INITIAL FIRE SAFETY INSPECTION REPORT

Ahsan Knitting Ltd.

RSC ID: 24475

Date: 04 October 2022

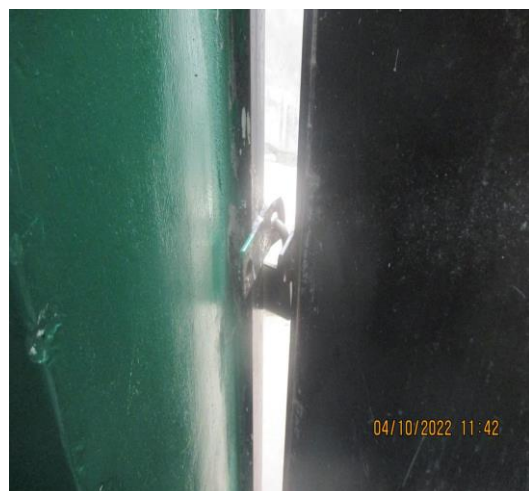
F-2	Fire Rated Construction	Rooms used for combustible storage at 1 st floor are not separated by fire rated construction.	Separate the dedicated storage rooms by minimum 1-hr fire-rated construction. Provide 0.75 hr. fire rated door and seal all penetrations and openings by 0.75 hr. (45 Minutes) fire rated fire rated barrier construction.	Within 3 Months
-----	-------------------------	---	--	-----------------
